February 12, 1992
LD-92-016

Docket No. 52-002

Subject: Response to NRC Requests for Additional Information

RESPONSE TO NRC REQUESTS FOR ADDITIONAL INFORMATION
STRUCTURAL AND GEOSCIENCES BRANCH

| SYSTEM 80+™ | <i>REPRESENTATIVE</i> A SURGE LINE SEISMIC ANALYSIS MODEL | Figure 3.7-34 |

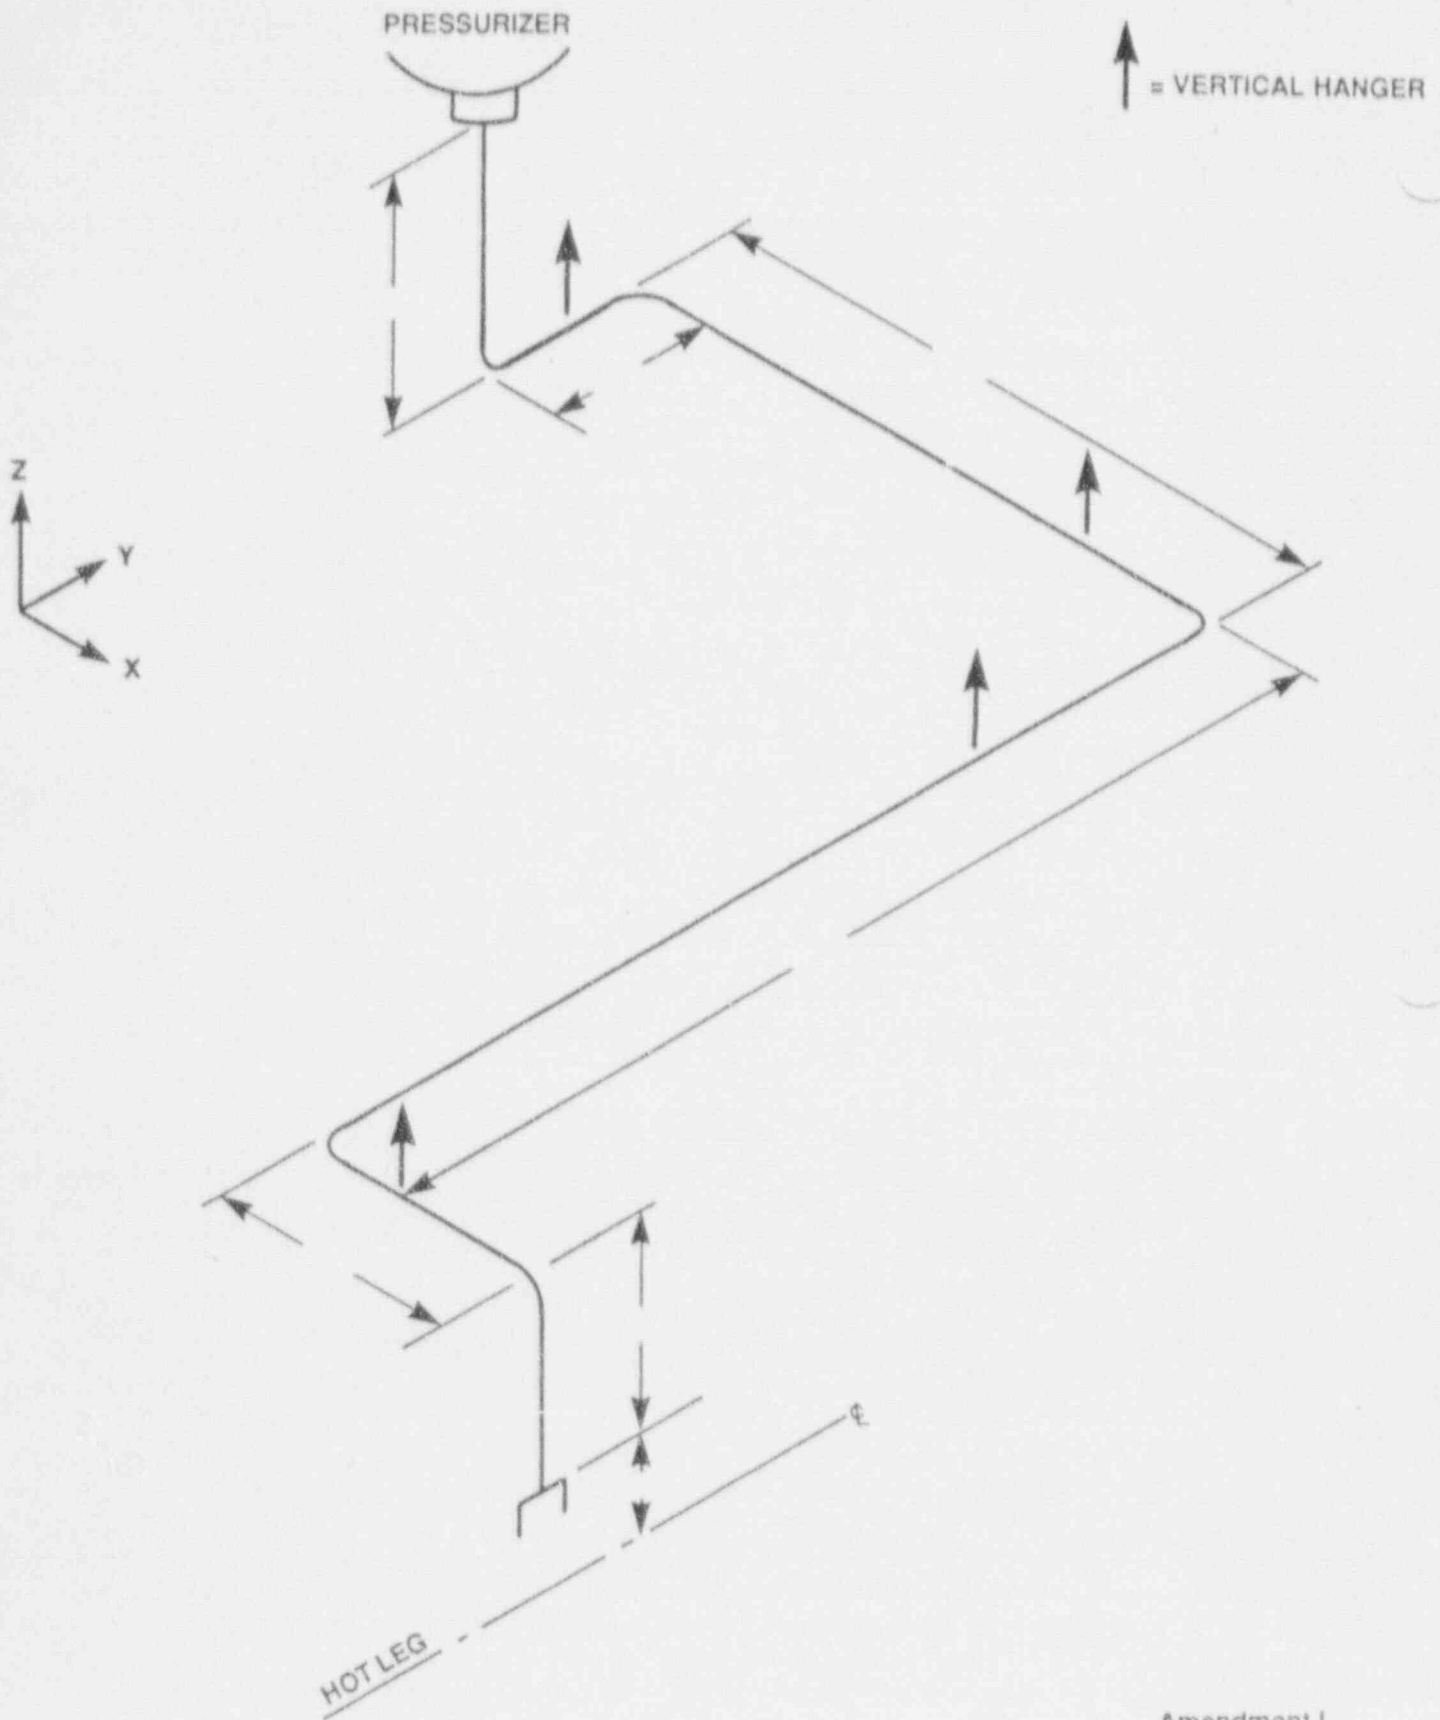
CESSAR-DC Section 3.7.2.1.2.2 states that a multimass model was used for the surge line dynamic analysis. The model is shown in Figure 3.7-34. However, no details of the number of mass points and degrees of freedom are provided.

The representative model of the surge line shown in Figure 3.7-34 has sixteen mass points, each with three degrees of freedom (x, y and z). The number of mass points required for the System 80+ surge line will be determined during the detailed design. The number of mass points and degrees of freedom will meet the requirements of the acceptance criteria of SRP 3.7.2, Rev. 2, Subsection II.1.a.(iii).

CESSAR-DC Section 3.7.2.1.2.2 and Figure 3.7-34 will be revised in a future submittal to note that Figure 3.7-34 is a representative surge line seismic analysis model.

A representative

Figure 220.12-1 - Axisymmetric model of the SCV used in fine-tuning of the SSI model.

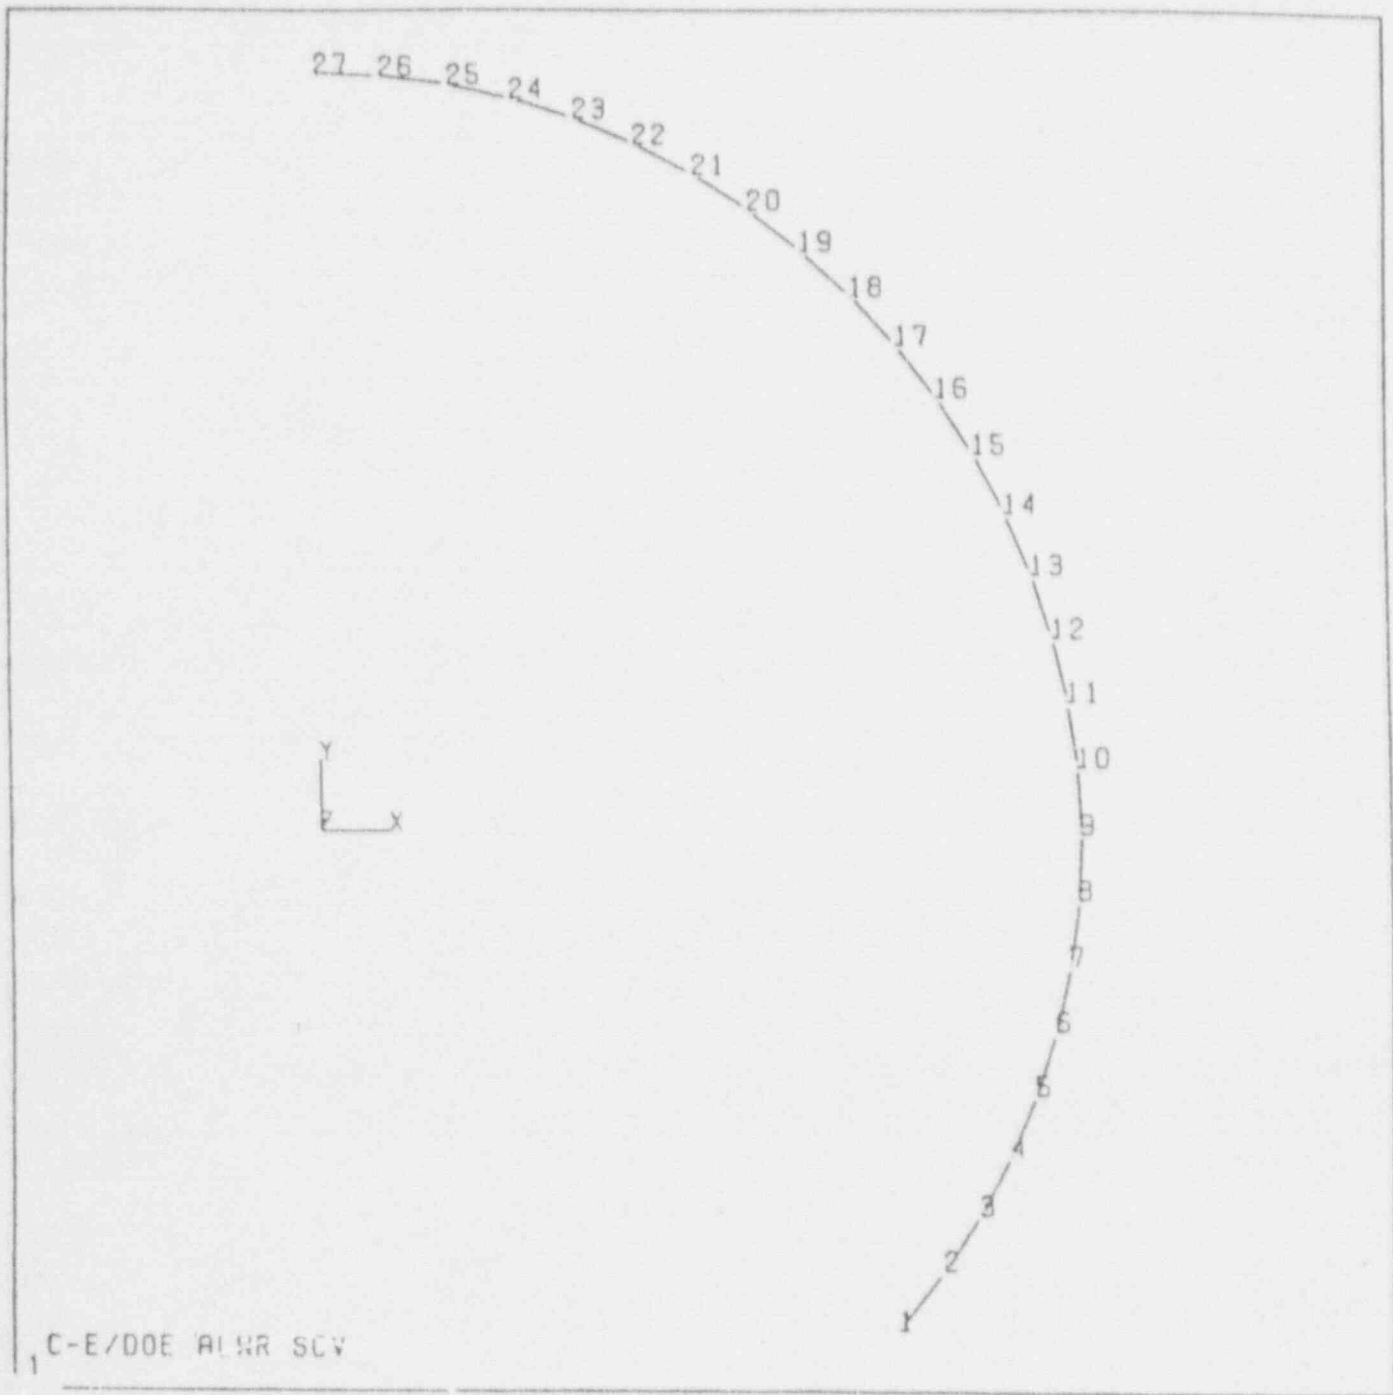
Section 3.7.2.1.1 - The mesh of the finite element model shown in Figure 3.7-30 seems coarse. Is there any parametric study performed to determine if stiffness characteristics of the containment vessel are properly represented by these coarse mesh finite elements?

The finite element model of the Steel Containment Vessel (SCV) shown in Figure 3.7-90 was used only in the soil-structure interaction (SSI) analysis. Typically, stick models are used in SSI analyses of containment structures. However, in order to capture more accurately "breathing" modes and other higher order modes of the containment, a finite element model with shell elements was developed for the SCV.

A comparison of the SCV SSI model with a more detailed axisymmetric model was made in order to fine tune the natural frequencies and mass participation factors of the SCV SSI model. The axisymmetric model shown in Figure 220.12.1 was developed with the computer program ANSYS and was used as a benchmark for this fine tuning. The SCV SSI model properties were adjusted to get a match of dynamic properties with the more detailed ANSYS model.

Figure 220.16-1 - Detailed 3D Finite Element Model of Internal Structure

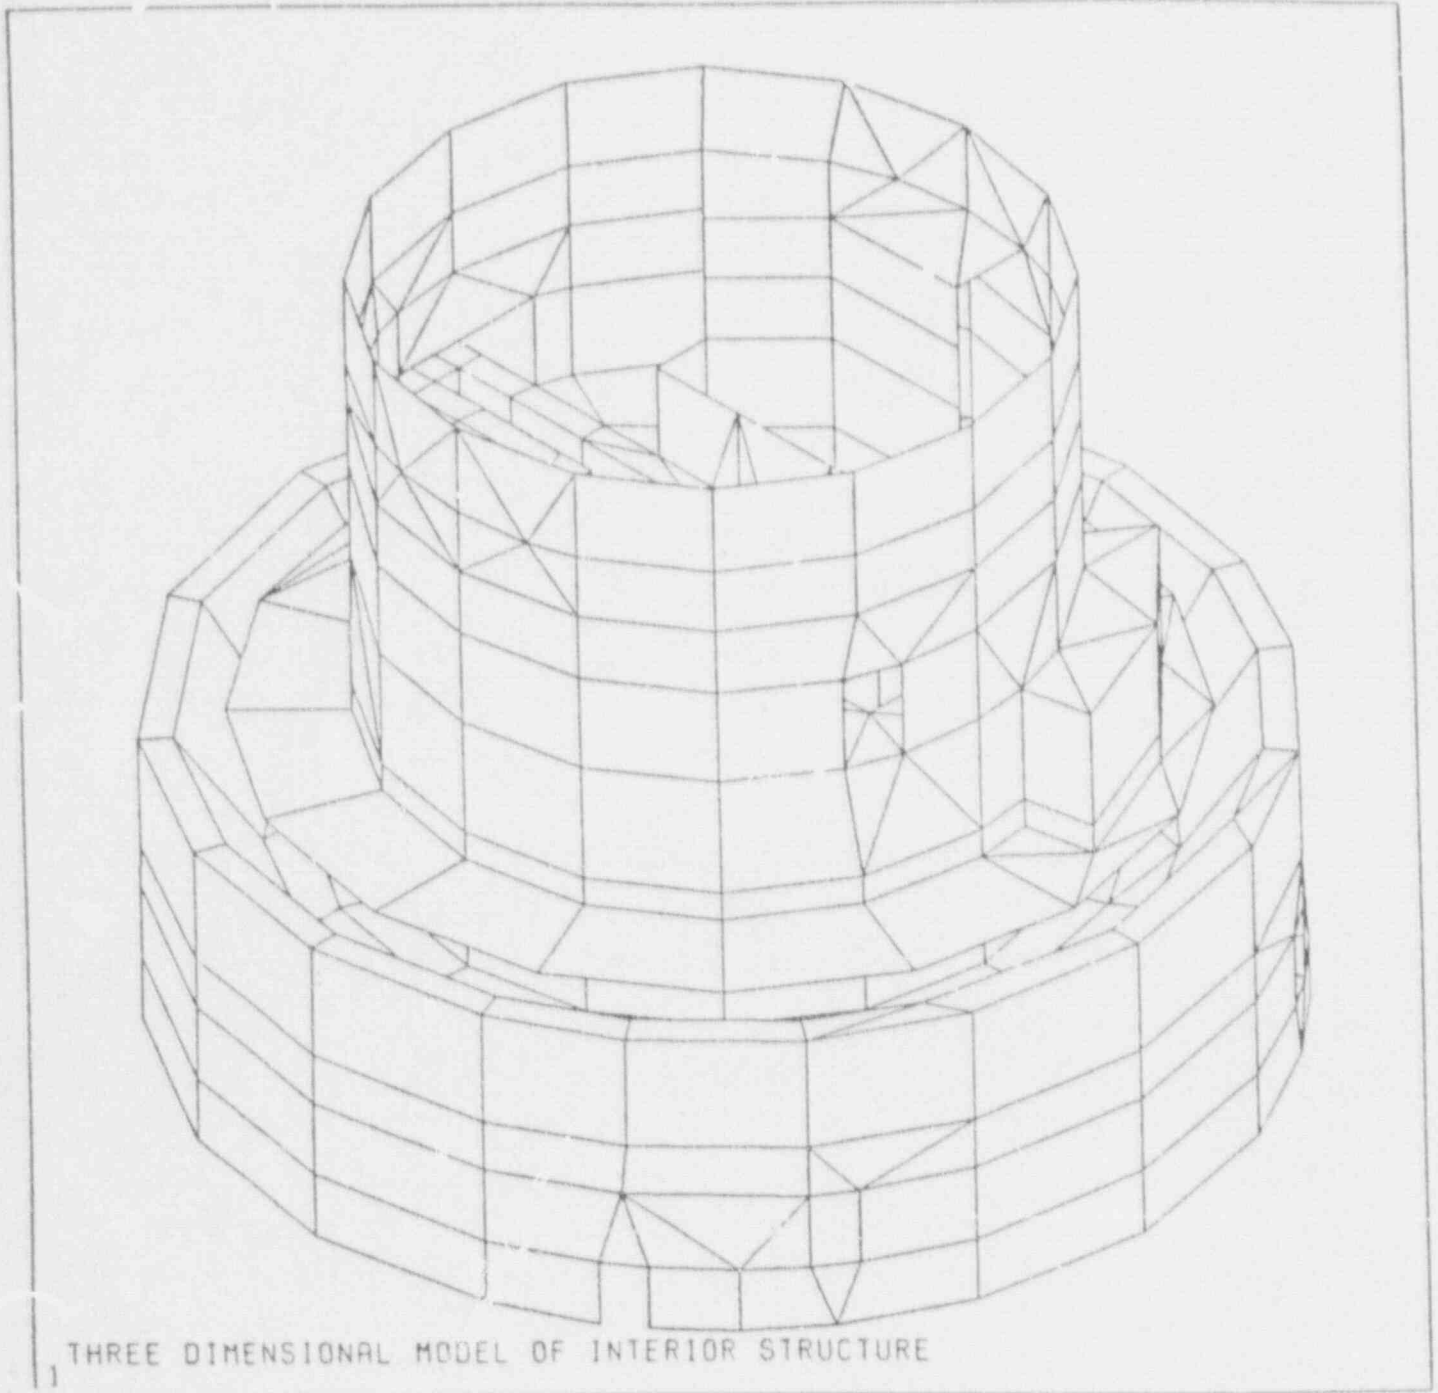
Section 3.7.2.1.1 - Does the combined model shown in Figure 3.7-31 include any simplified building or NSSS models? What are these simplified models? What is the purpose of this combined model? Provide some analysis results of this combined model.

As described in Section 3.7.2.3.4.1 of CESSAR-DC, the IS stick model was developed and fine tuned based on a detailed 3D finite element model. The detailed 3D finite element model is shown in Figure 220.16-1, and it was developed according to the procedure described in Section 3.7.2.3.4.1.1 of CESSAR-DC. In a similar manner, the SB stick model was developed and fine tuned based on a detailed axisymmetric model of the SB, shown in Figure 220.16-2.

Figure 220.18-1 • SSI Analysis Flow Diagram

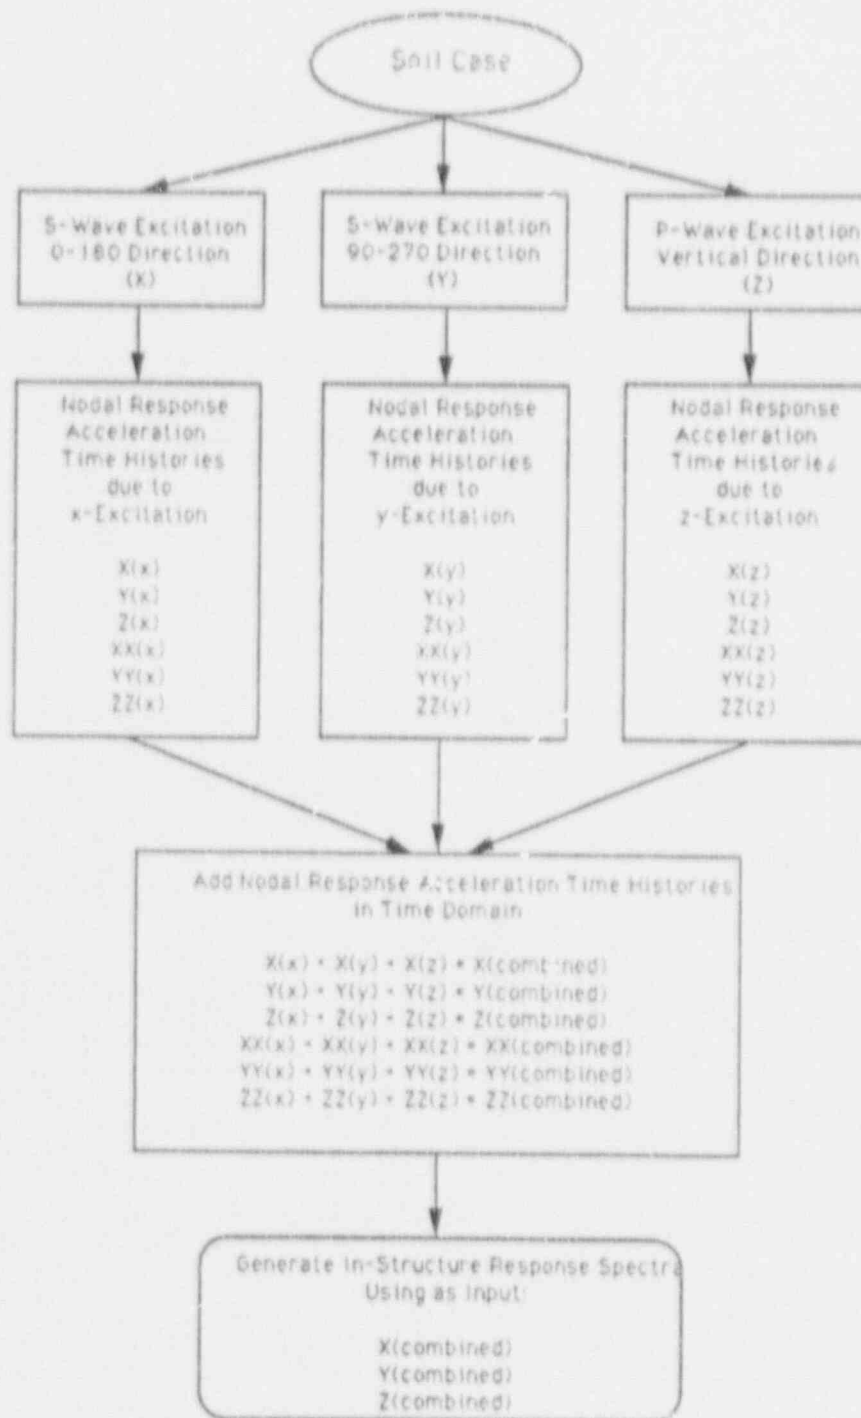
Section 3.7.2.1.2.1 - How many SASSI computer runs were performed for all soil conditions considered in Section 3.7.1.1? It is expected that there are a lot of time histories available because there are many soil cases and there are at least one P-wave and two S-waves. How were the basemat acceleration time histories obtained in these runs used for the analysis of various NSSS models described in Section 3.7.2.1.2.1 and Figures 3.7-32 through 3.7.39? Provide responses to these questions also for the combined model and the structures discussed in Section 3.7.2.1.1.

For each of the above cases, SASSI runs were performed according to the sequence shown in the flow diagram of Figure 220.18-1. For horizontal excitation, two runs were performed using vertically propagating S-waves, one with excitation in the 0-180 direction and one with excitation in the 90-270 direction. For vertical excitation, one run was performed using vertically propagating P-wave. For each of the three runs, at every node of the structure, response was obtained at all six degrees of freedom, i.e., three translational (X, Y, Z) and three rotational (XX, YY, ZZ). The response time histories at each degree of freedom were subsequently added algebraically in the time domain to obtain the combined response time histories due to the three excitations. Finally, the combined response time histories were used as input to generate response spectra at the selected building locations.

| SYSTEM 80 + TM | STICK MODEL OF INTERNAL STRUCTURE (FOR HORIZONTAL ANALYSIS) <i>DELETE</i> ↗ | Figure 3.7-28 |

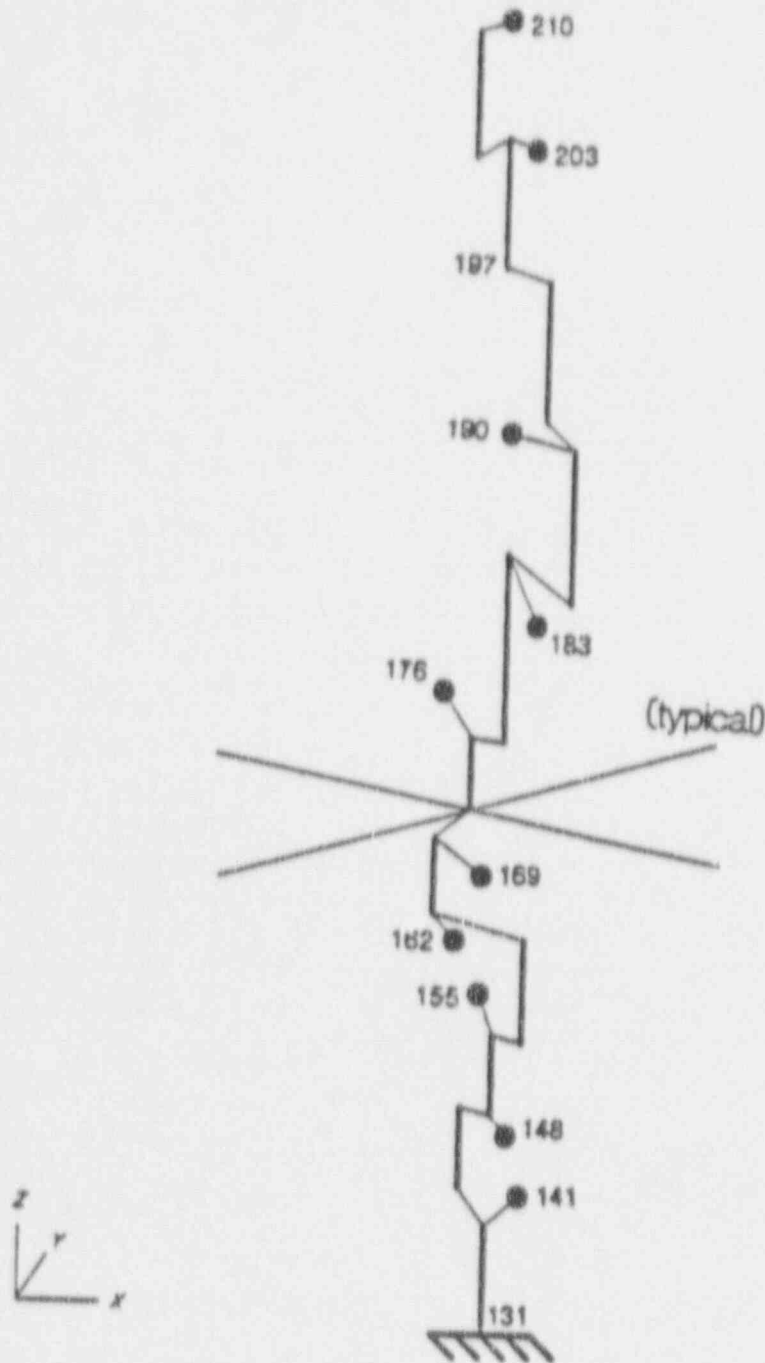
Figure 3.7-28 shows the stick model of the internal structure for horizontal seismic analysis. Provide a figure of the stick model used for vertical seismic analysis. (see also Comment 220.24)

The stick model shown in Figure 3.7-28 is typical of the horizontal and vertical model. The nodes shown represent the mass nodes which are at the same location in both models. The difference in the models is the x-y plane location of the sticks, which are at the center of rigidity. The sticks represent the stiffness between floor elevations. The horizontal model sticks are located at the shear center of the section. The vertical model sticks are located at the bending center of the section.

Figure 3.7-28 will be revised in a future amendment to CESSAR-DC to clarify this.
